**Planning Proposal to Rezone Part 129 Marys Mount Rd and 110 – 118 Middle Arm Road to R2 Low Density Residential and Part C2 Environmental Conservation.**

## **ATTACHMENT 1 - DETAILED COMMENTS**

**Map 1.** SLWCA Map for Residential Sewered Development.

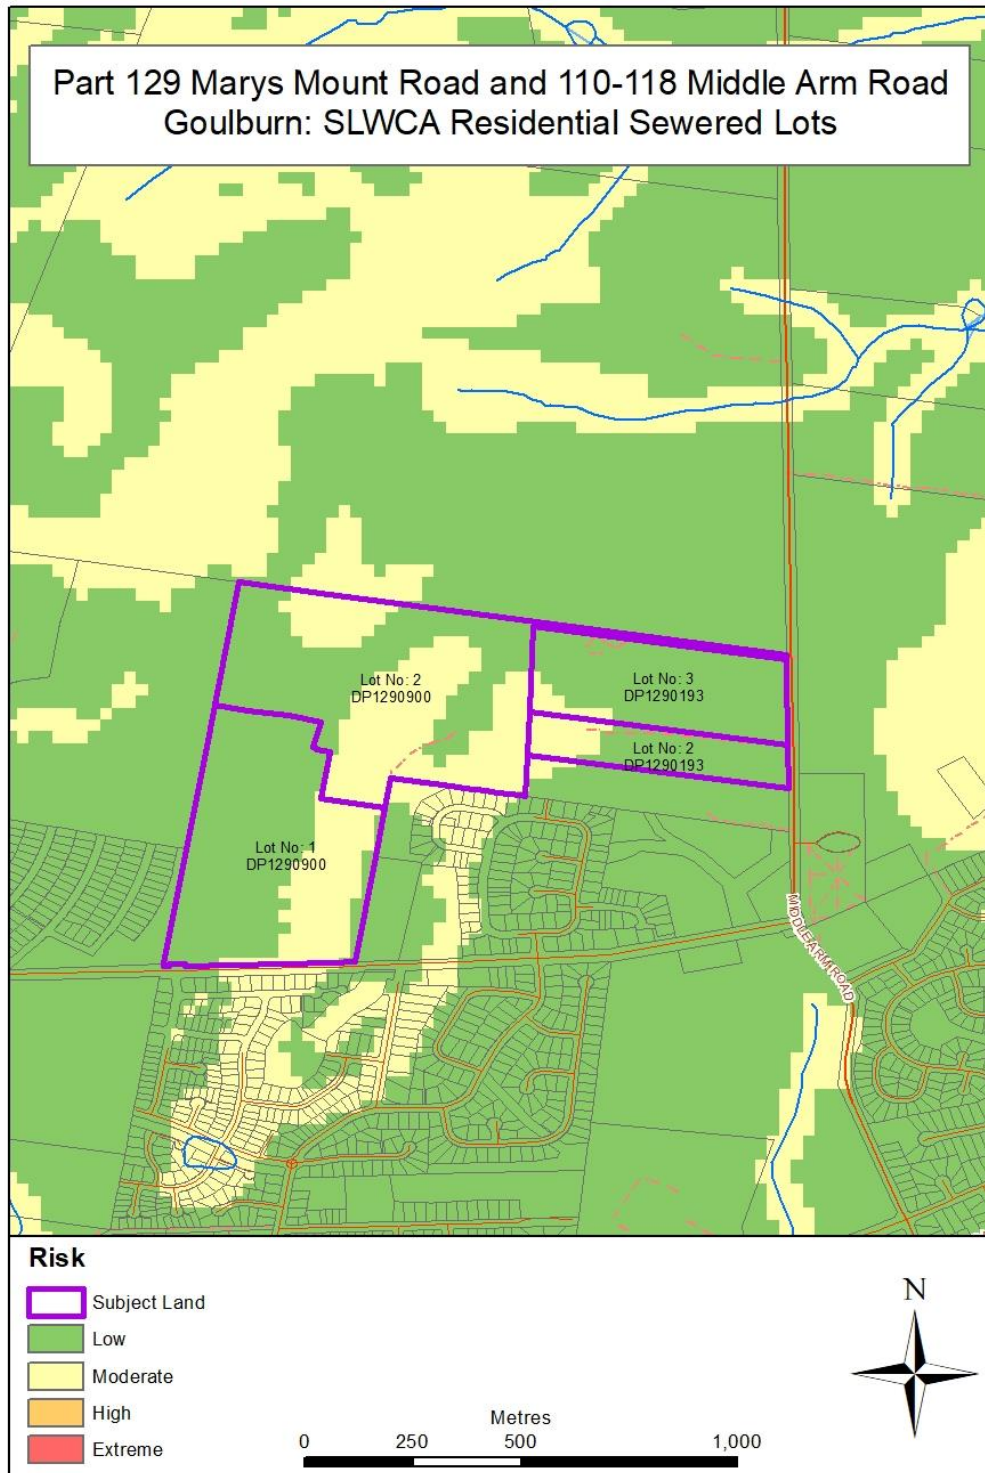
To complete the consideration of Direction 3.3, we include a Strategic Land and Water Capability Assessment (SLWCA) map in Attachment 2. The outcomes of the SLWCA show that for residential sewer development the water quality risk varies from LOW to MODERATE. Areas with a LOW risk have a HIGH capability for the intended land use while areas with a MODERATE risk have MODERATE capability.
